Attention:
Village of Bayside, WI
Architecture Review Committee

| PROJECT/SITE OWNER: Al Brotton PROJECT ADDRESS: 600 W Laramie Ln | PROJECT SUMMARY: New 155 feet of 4'high cedar dog eared fence |

VILLAGE CODE REVIEW

PLAT OF SURVEY

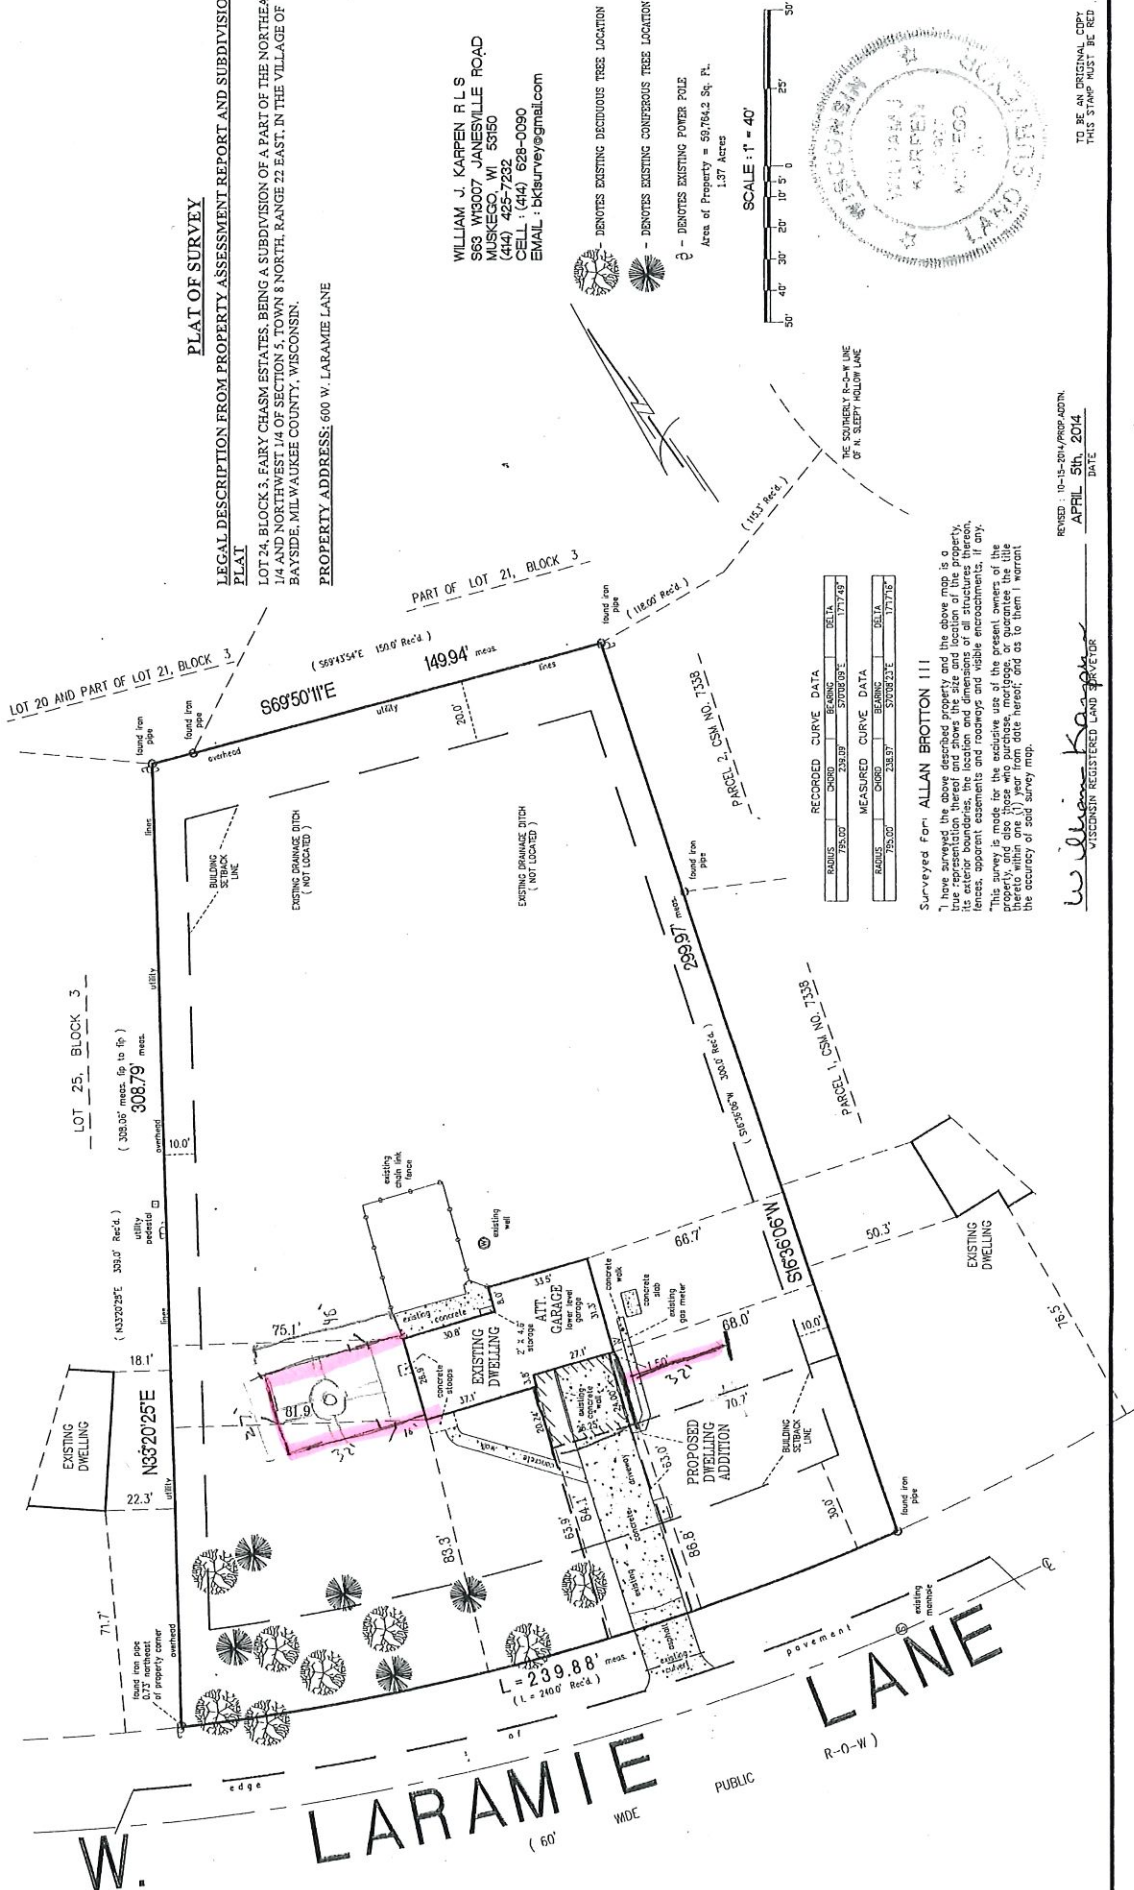
1. Current fence ordinance 104-125 (C) does not allow fences to exceed 50% of the perimeter of the property. The perimeter of the property is approximately 998 feet. The applicant states the proposed fence is 155 feet. This is 15.53% of the perimeter of the property.
2. The four-foot-high cedar Dog Eared fence is listed as having an 8" spacing between boards, which complies with the ordinance. **They also did not specify if they will be staining, painting, or leaving it a natural color**
3. A current survey was provided
4. The board always considers matching fences with neighboring fences. **It does show the neighboring fence in the photos if there are any.**

Supporting documentation or testimony must be provide at the meeting to verify code compliance with the above observations in red.
